AS-BUILT BASELINE MONITORING REPORT

KEY MILL MITIGATION SITE

RE: Task 6 – Final As-built Baseline Monitoring Report
Key Mill Mitigation Site, Surry County
Yadkin River Basin – HUC 03040101
DMS Project ID No. 100025 / DEQ Contract #7180

DMS comment: There was considerable storm damage caused to the site during the winter/spring 2020. Please include a brief discussion regarding the impact and changes to the timeline this had on construction, repairs and asbuilt/MY0 data collection that followed.

Key Mill Mitigation Site - Record Drawings
 Surry County, North Carolina
 Bull Creek Reach 1B
 Stream Plan and Profile

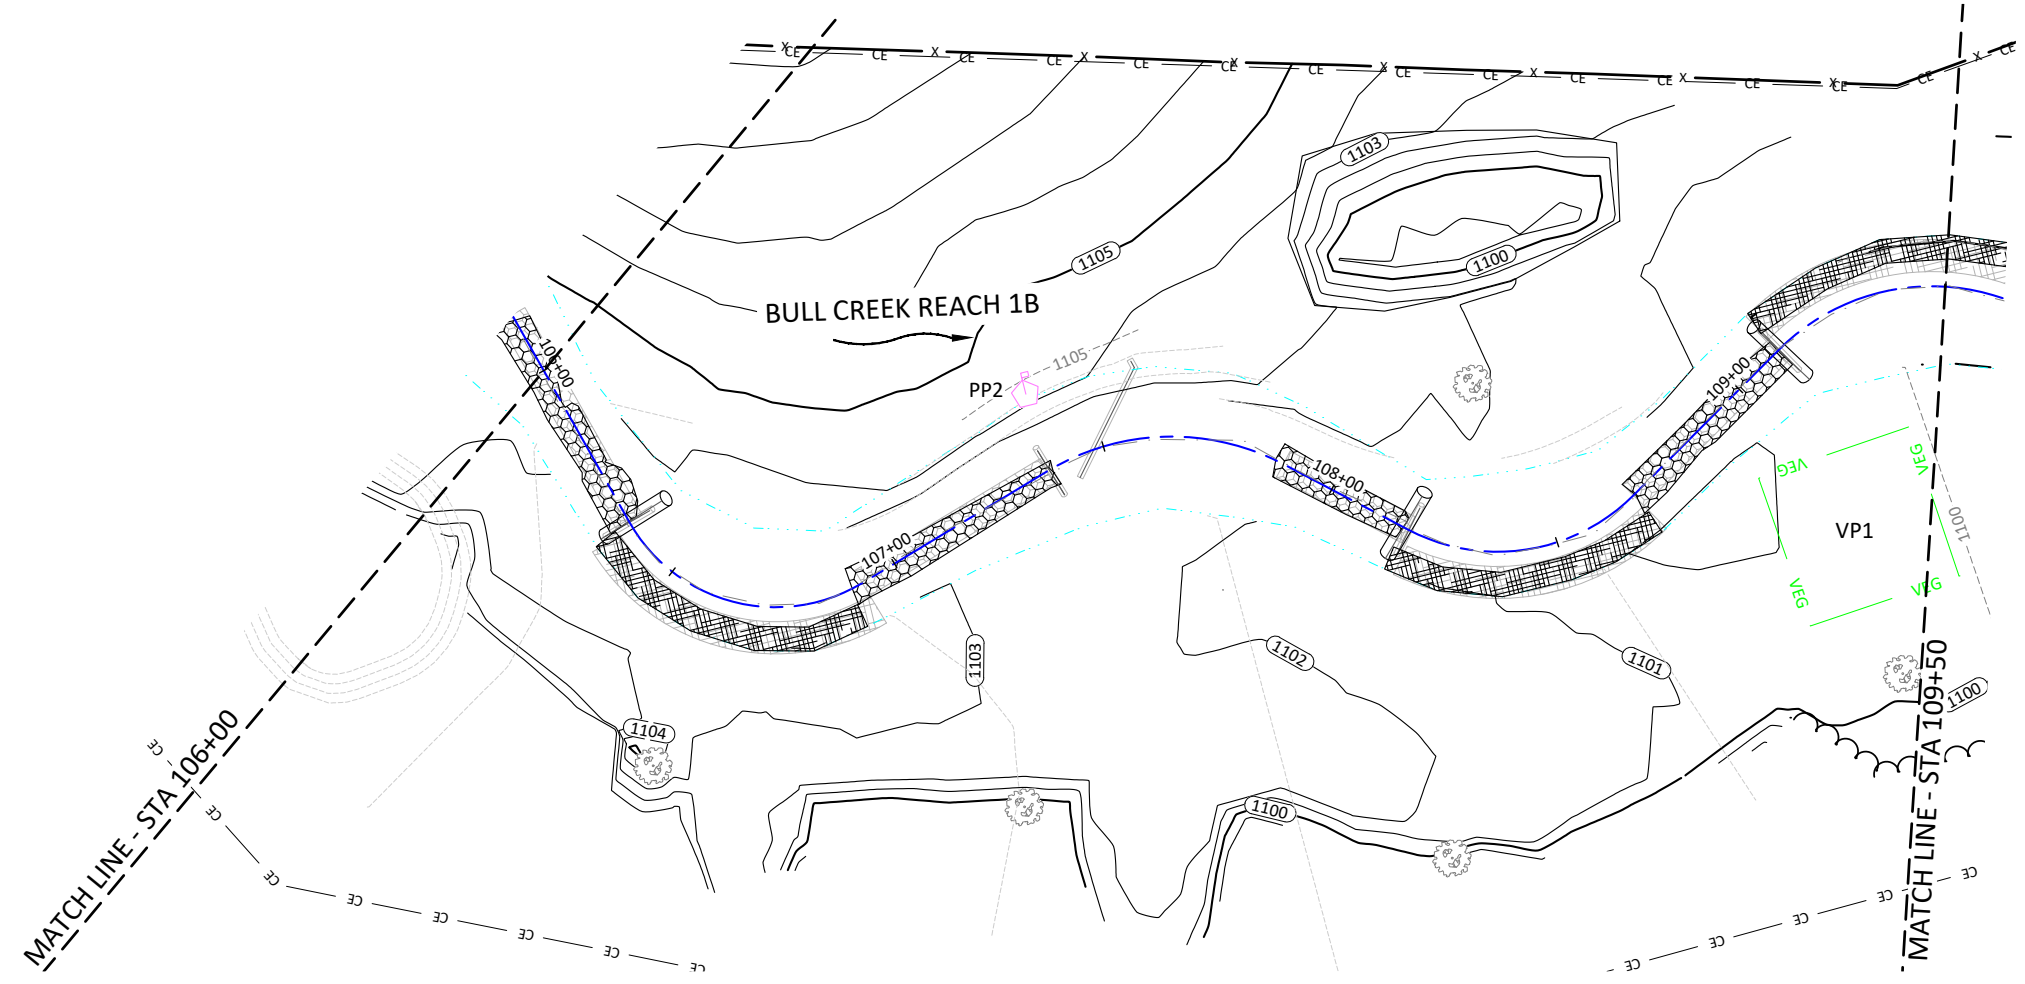
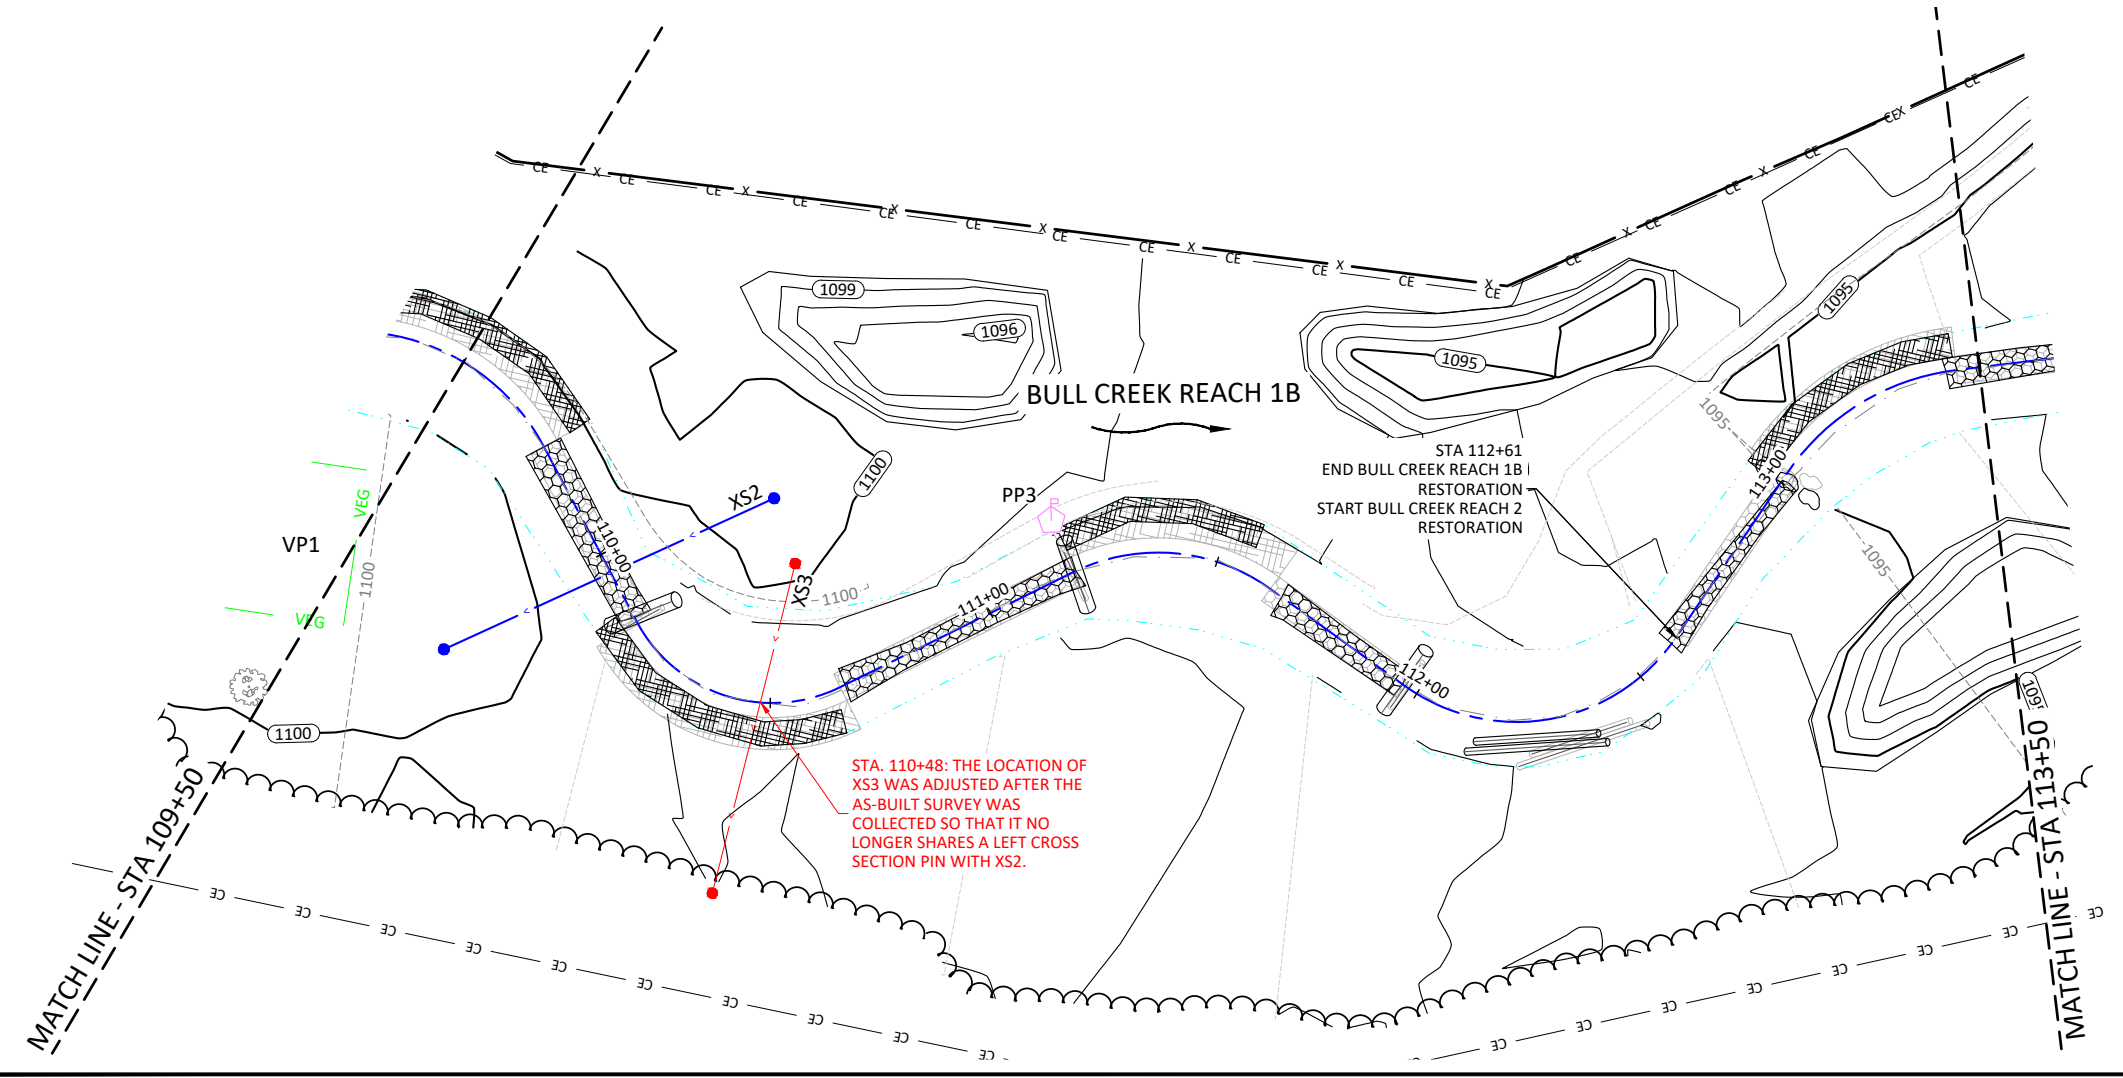
NOTE:
 1. STA. 107+40: THE LOG SILL AND LOG VANE WERE OMITTED DUE TO PRESENCE OF BEDROCK.

Key Mill Mitigation Site - Record Drawings
Surry County, North Carolina
 Bull Creek Reach 3
 Stream Plan and Profile

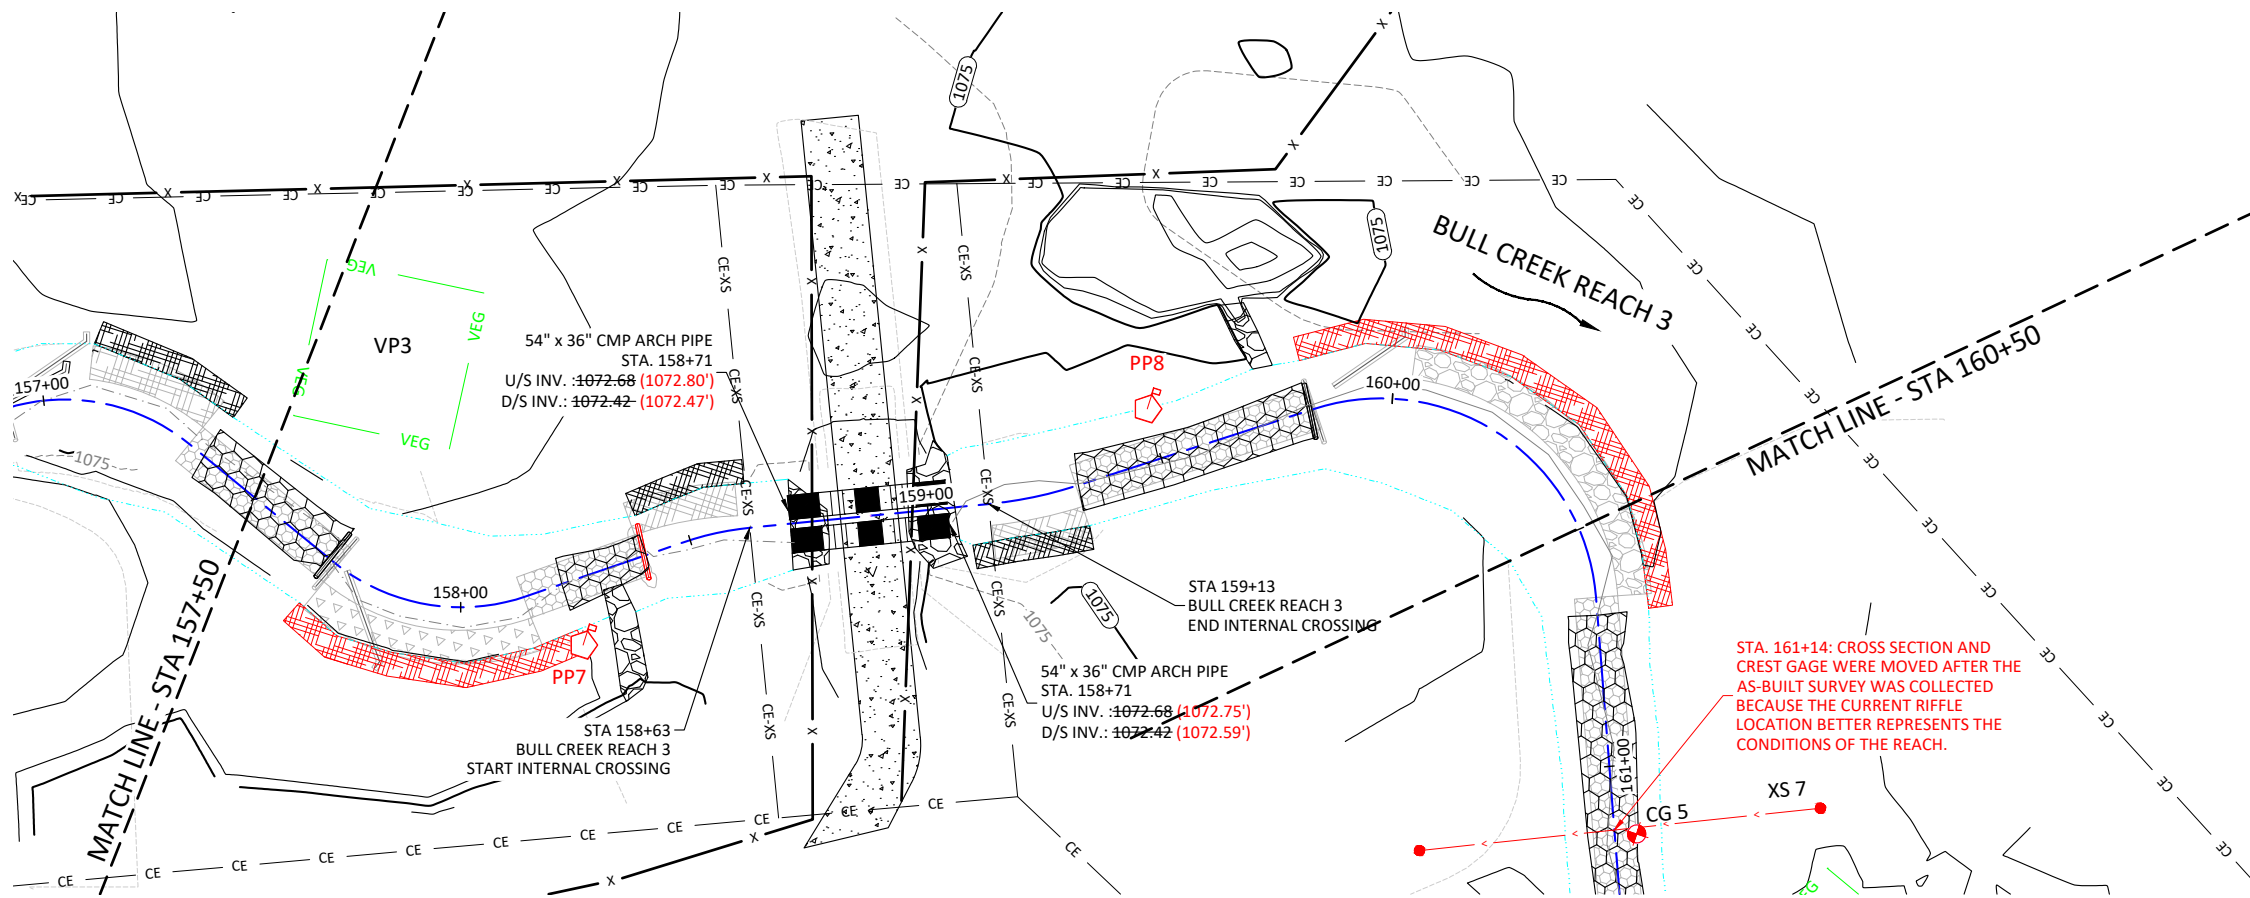
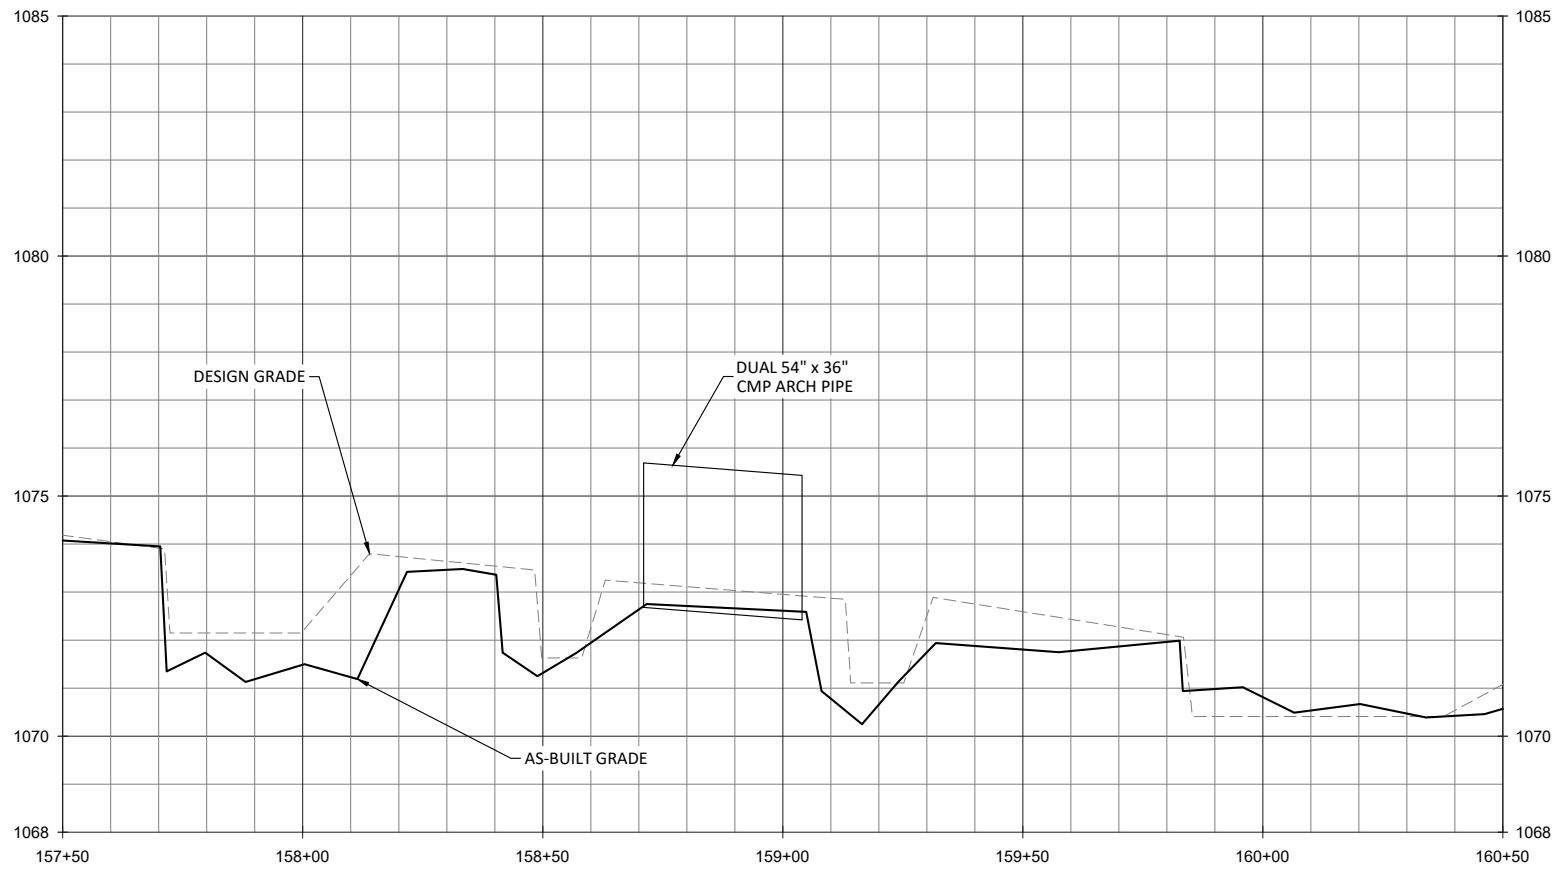
- NOTE:**
1. STA. 157+72: BRUSH MATTRESS REPLACED WITH BRUSH TOE DUE TO TIME OF YEAR OF INSTALLATION. LOG VANE REMOVED DUE TO BANK STABILITY AND HABITAT ENHANCEMENT PROVIDED BY BRUSH TOE.
 2. STA. 158+22: PHOTO POINT 7 WAS MOVED AFTER THE SURVEY WAS COMPLETED AT THE REQUEST OF DMS TO CAPTURE A DOWNSTREAM VIEW OF THE CULVERT CROSSING.
 3. STA. 158+40: ROCK SILL REPLACED WITH LOG SILL DUE TO LOCAL MATERIAL AVAILABILITY AND SIMILAR FUNCTIONALITY.
 4. STA. 159+50: PHOTO POINT 8 WAS MOVED AFTER THE SURVEY WAS COMPLETED AT THE REQUEST OF DMS TO CAPTURE AN UPSTREAM VIEW OF THE CULVERT CROSSING.
 5. STA. 159+84: BRUSH TOE WAS SUBSTITUTED FOR BOULDER TOE AND LOG VANE REMOVED DUE TO LOCAL MATERIAL AVAILABILITY AND THE BANK STABILITY AND HABITAT ENHANCEMENT PROVIDED BY BRUSH TOE.
